ORIGINATION FORM

Proposed Revisions to a Standard Plans Index
(Please provide all information — Incomplete forms will be returned)

Index Number: 700-120

Index Title: Enhanced Highway Signing Assemblies

LAST REVISION	REVISION	DESCRIPTION: 11/01/21	 FY 2021-22 STANDARD PLANS	ENHANCED HIGHWAY SIGNING ASSEMBLIES	INDEX 700-120	SHEET 11 5 of 10
---------------	----------	---------------------------------	--	-------------------------------------	------------------	---------------------------------------

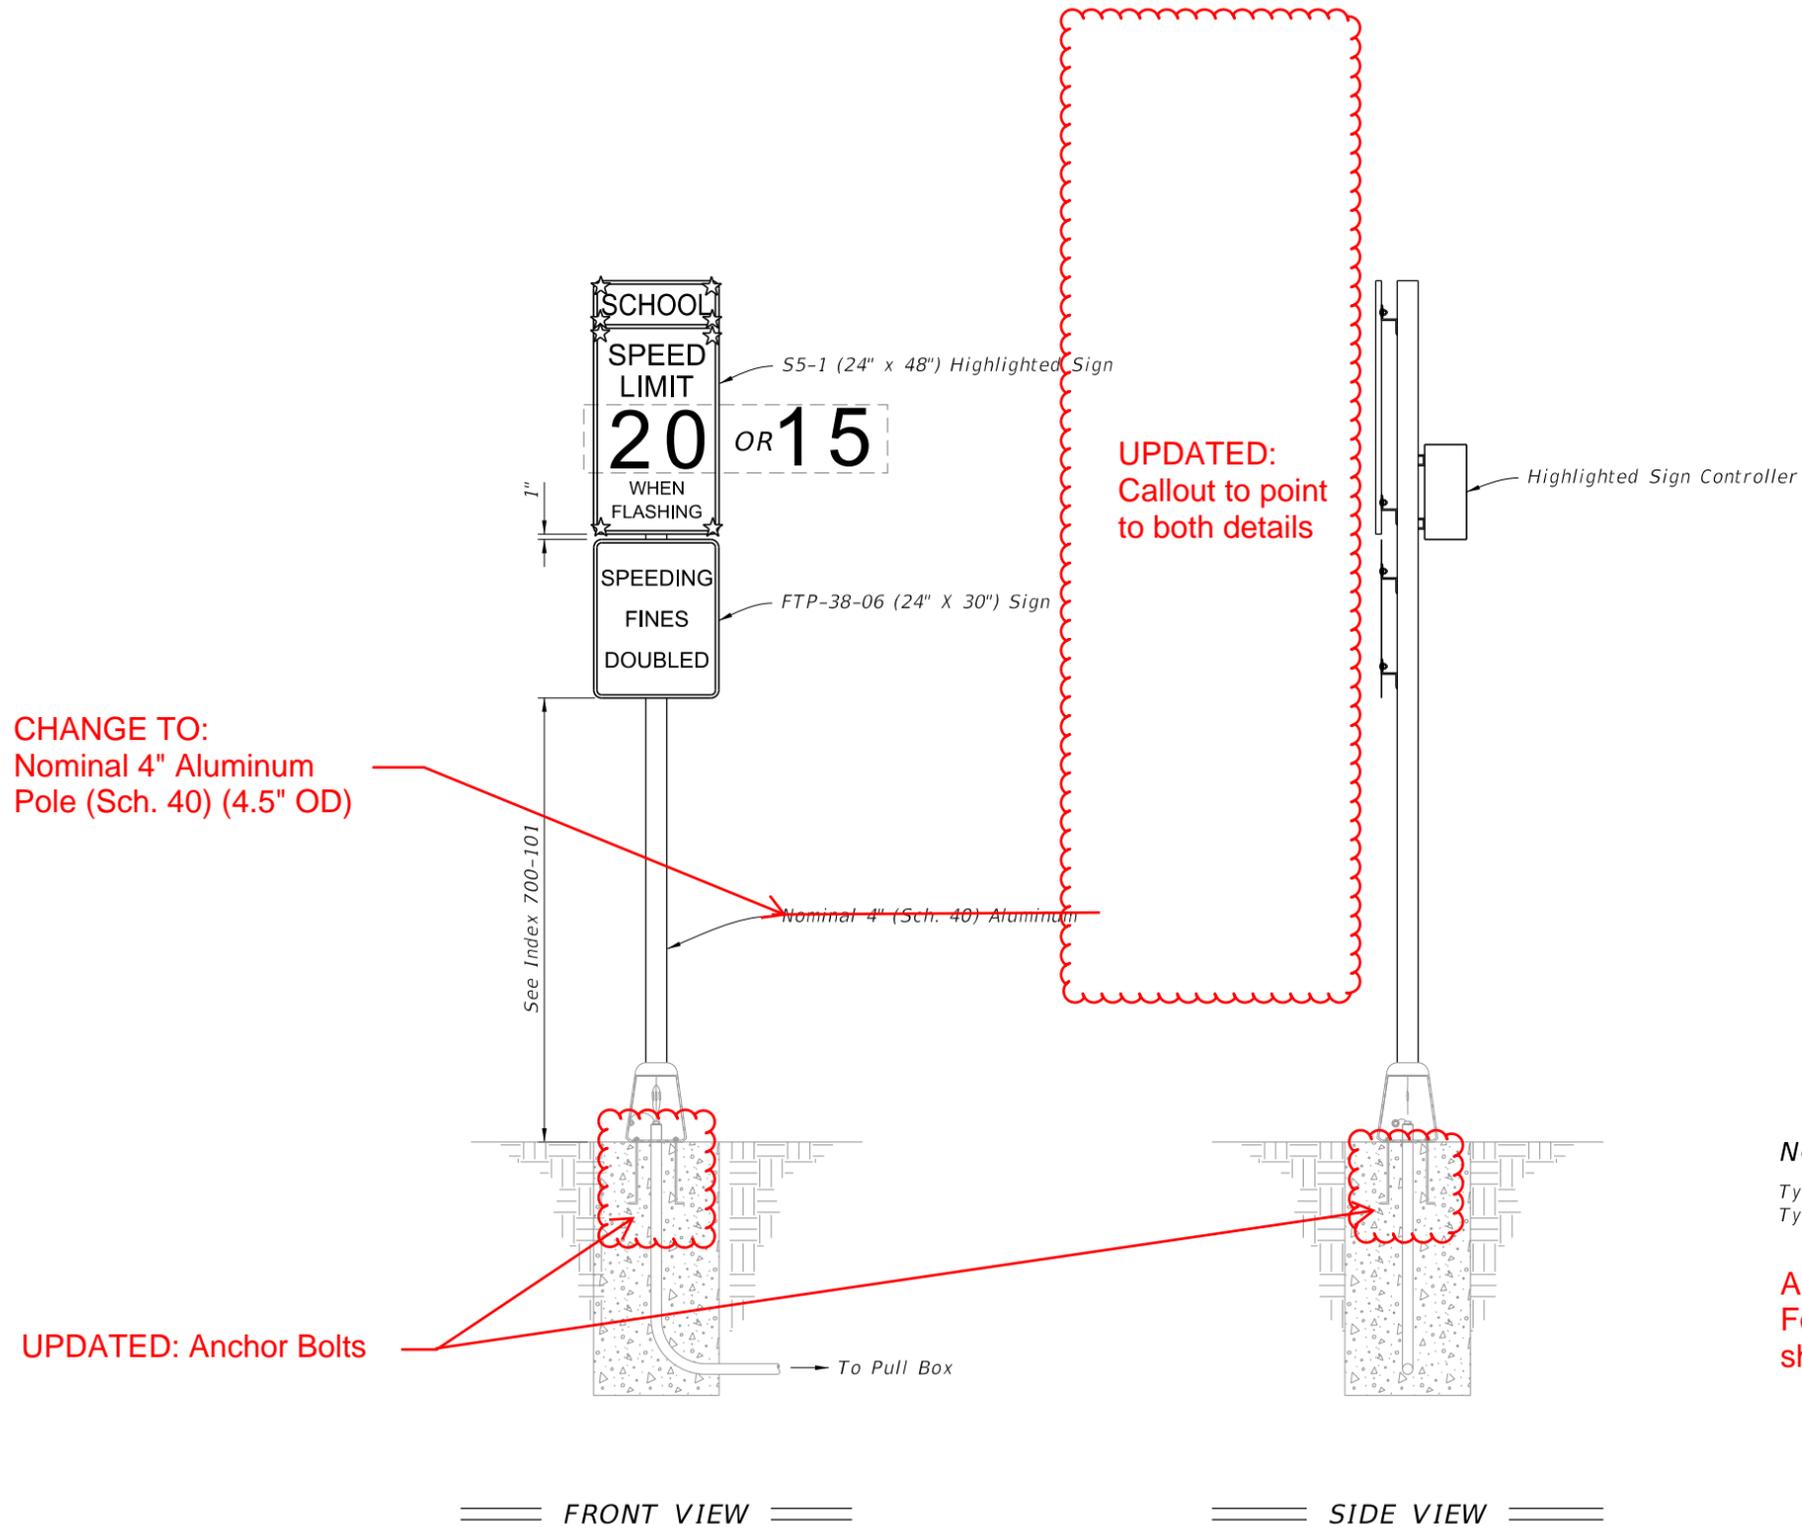
ADDED NOTE:
Foundation reinforcement not shown.

SHEET **11**
 6 of ~~10~~

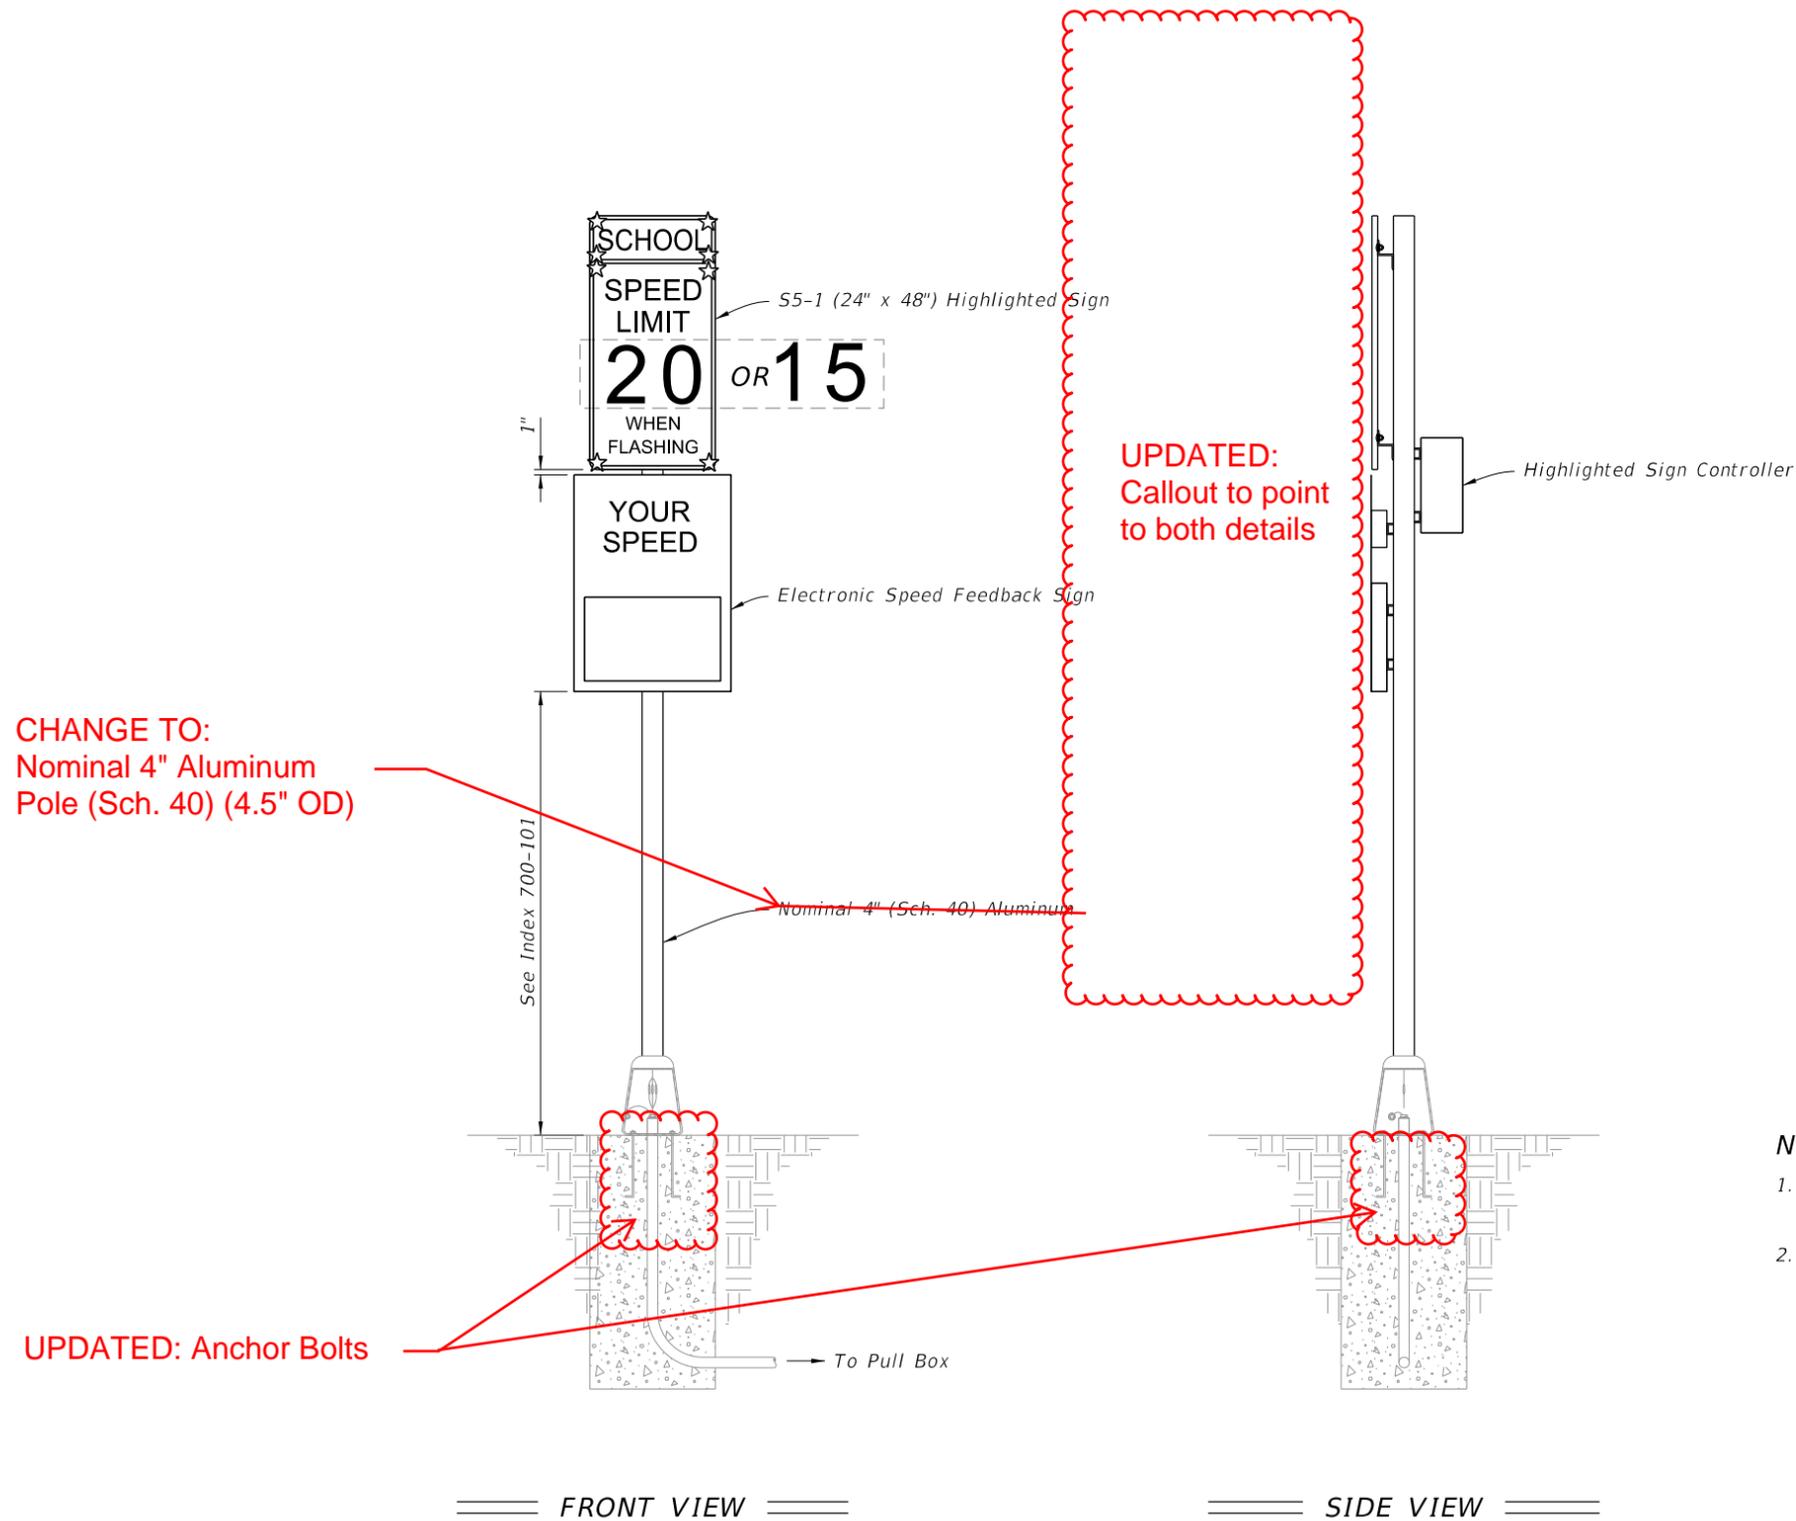
ADDED NOTE:
 Foundation reinforcement not shown.

ROADSIDE SIGN ASSEMBLY-5

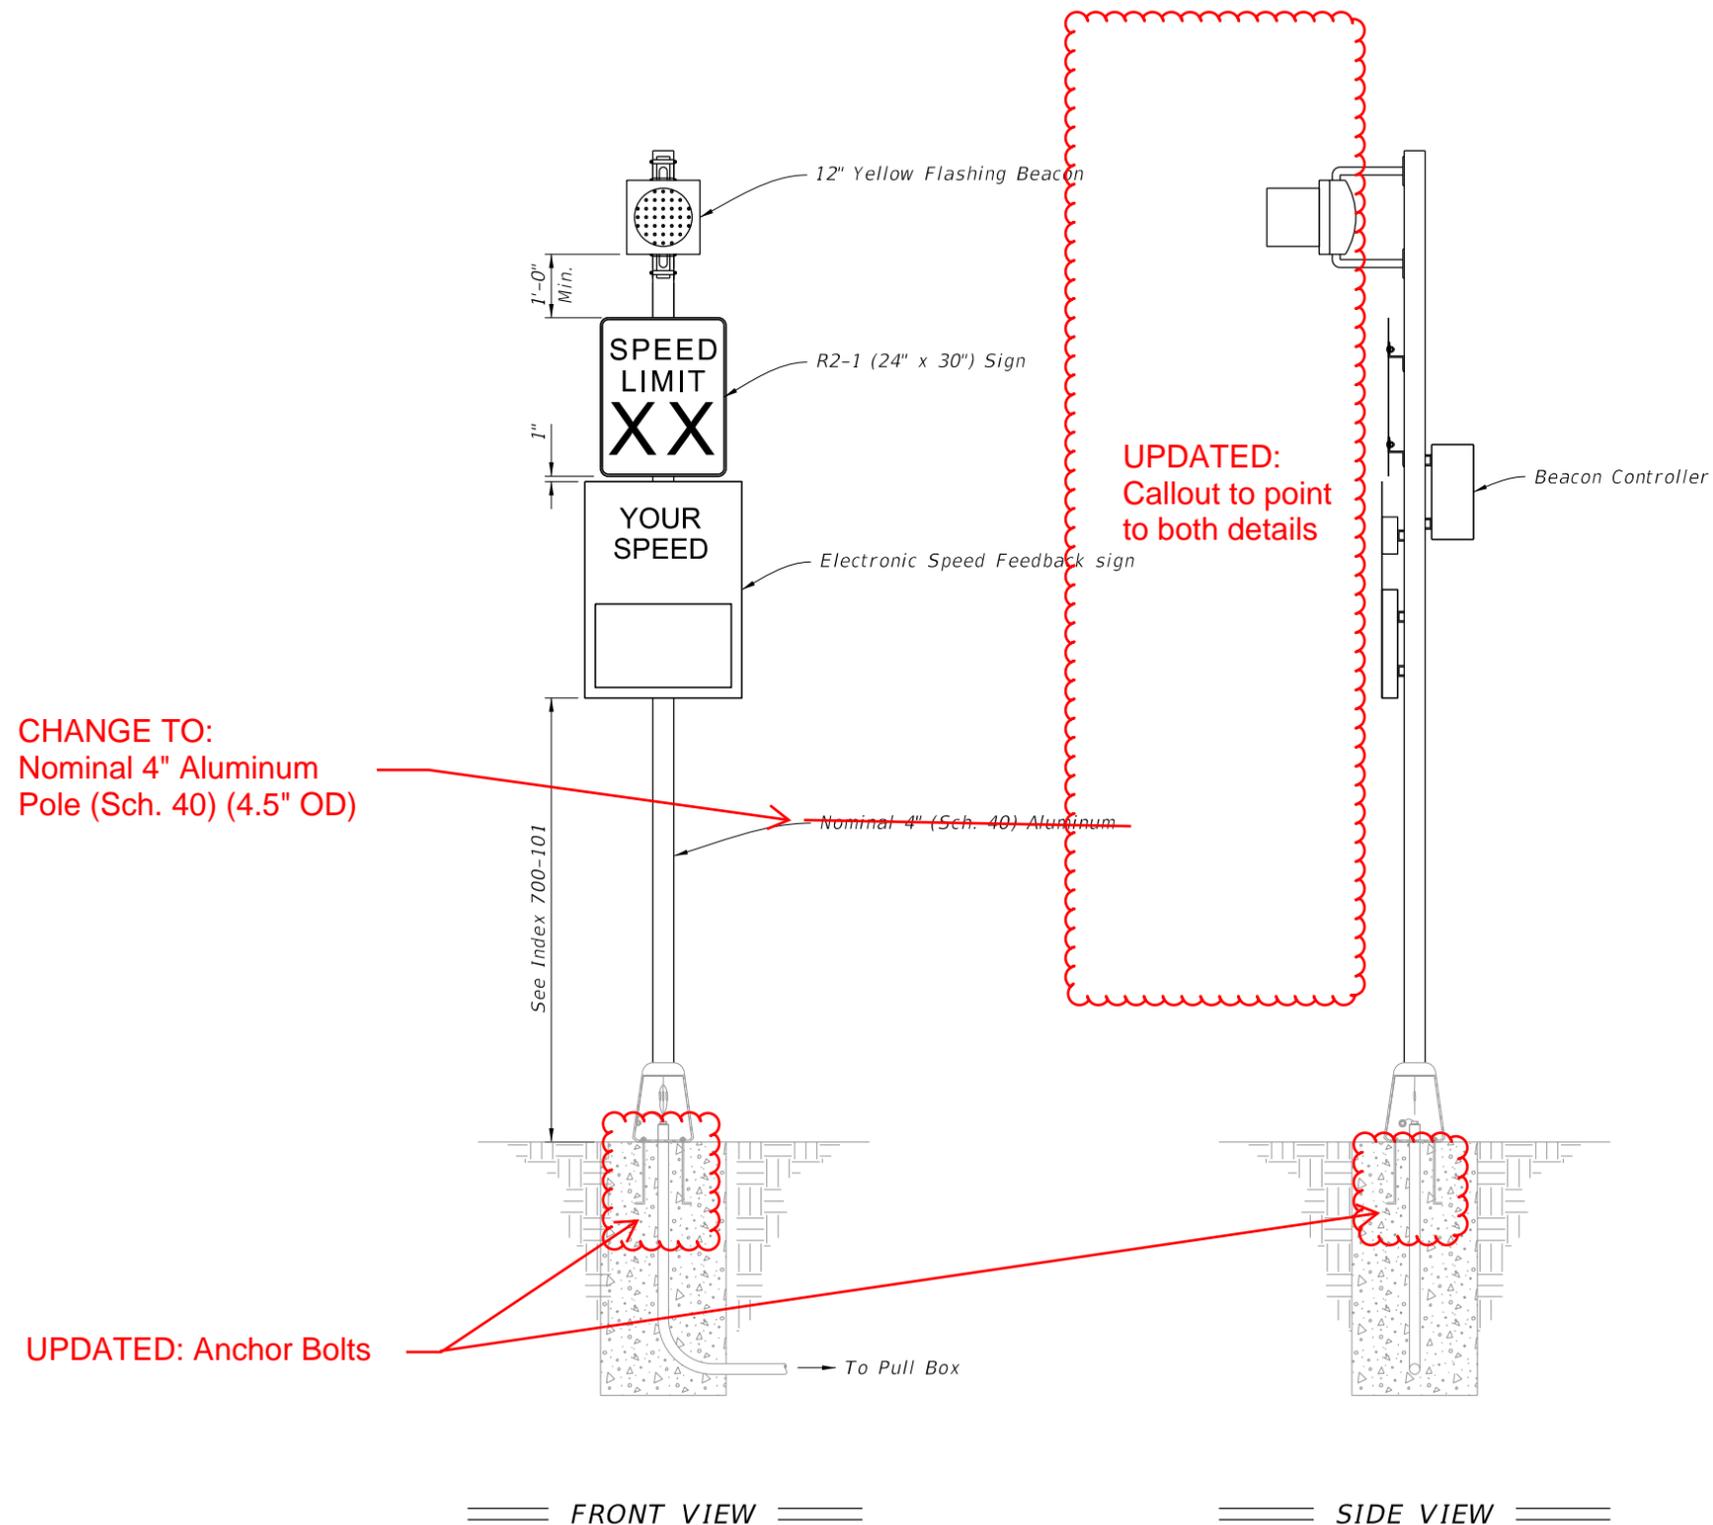
ADDED NOTE:

Foundation reinforcement not shown.

ROADSIDE SIGN ASSEMBLY-6

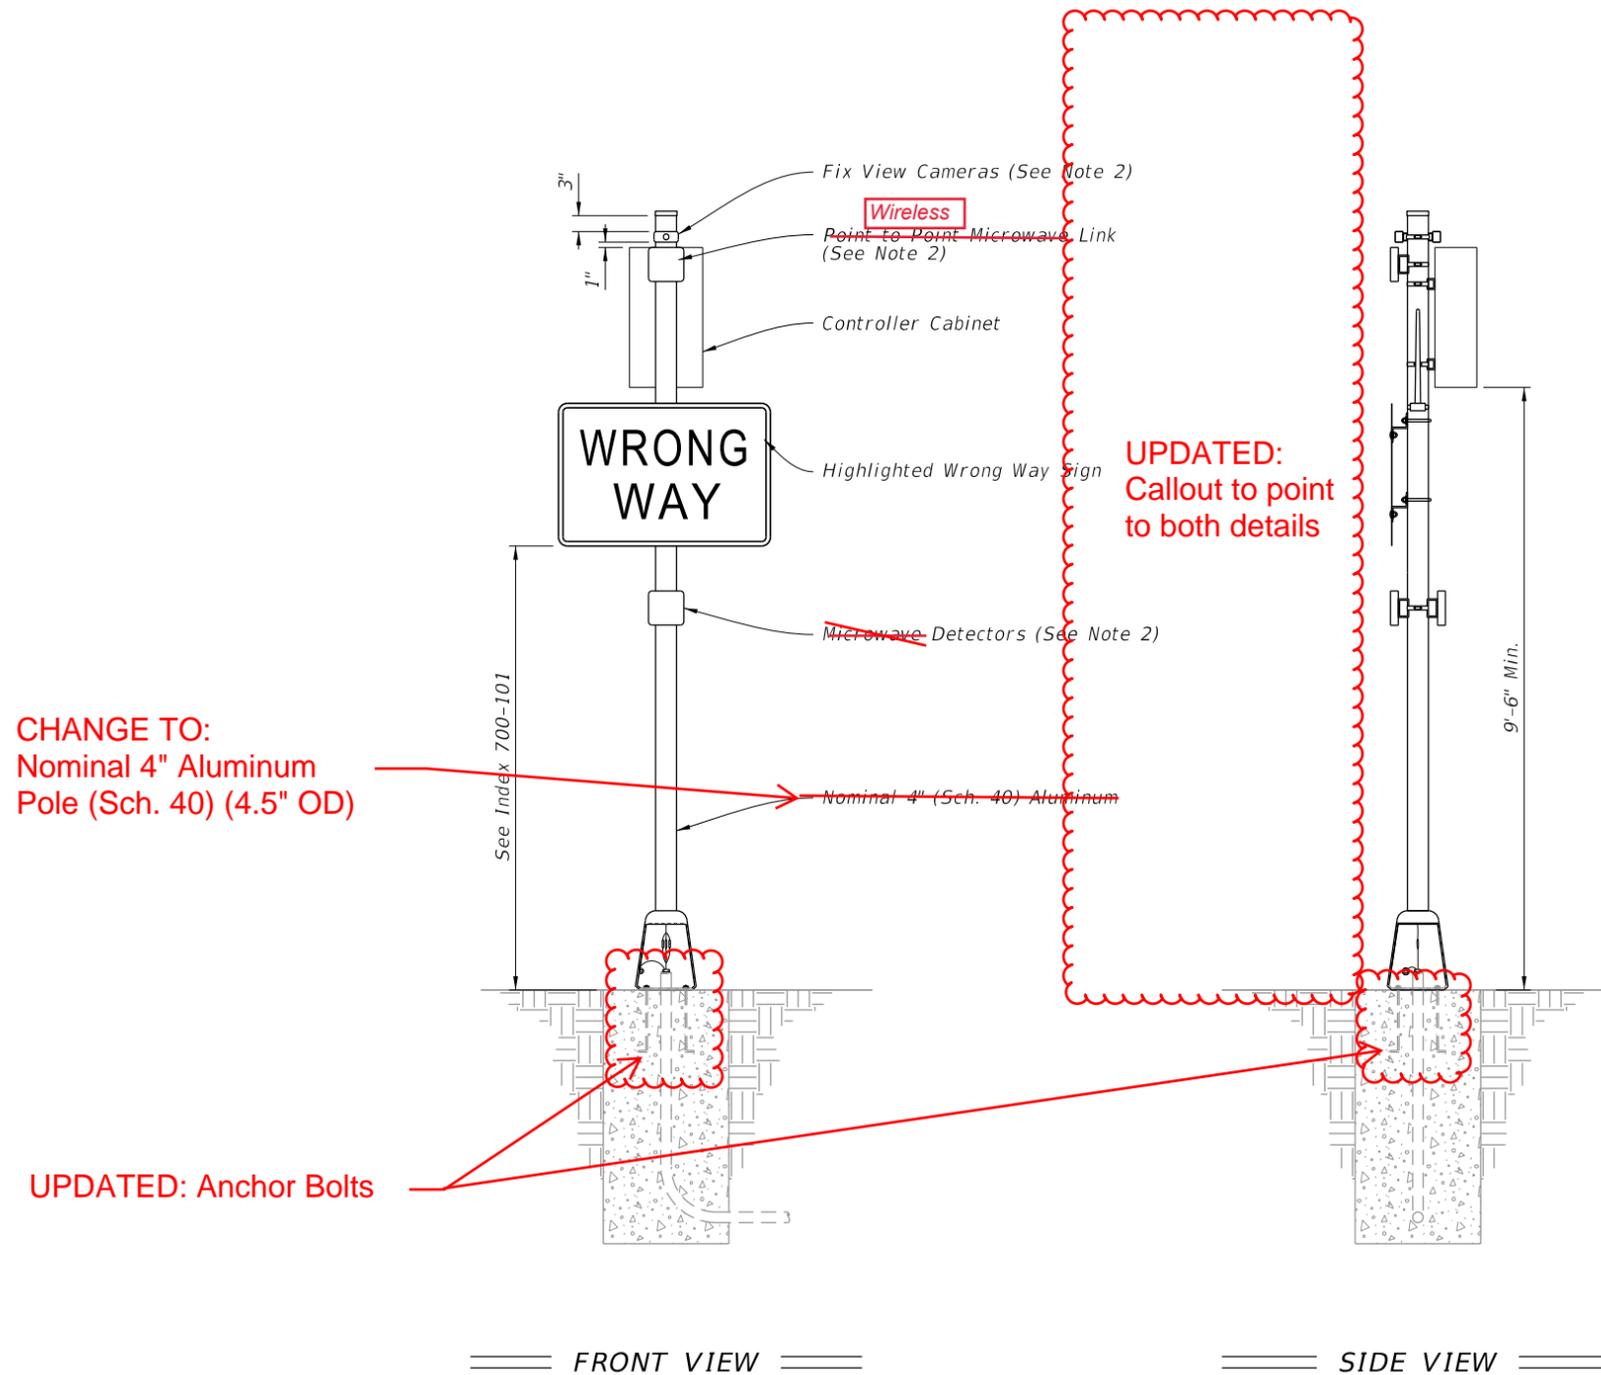
ADDED NOTE:
Foundation reinforcement not shown.
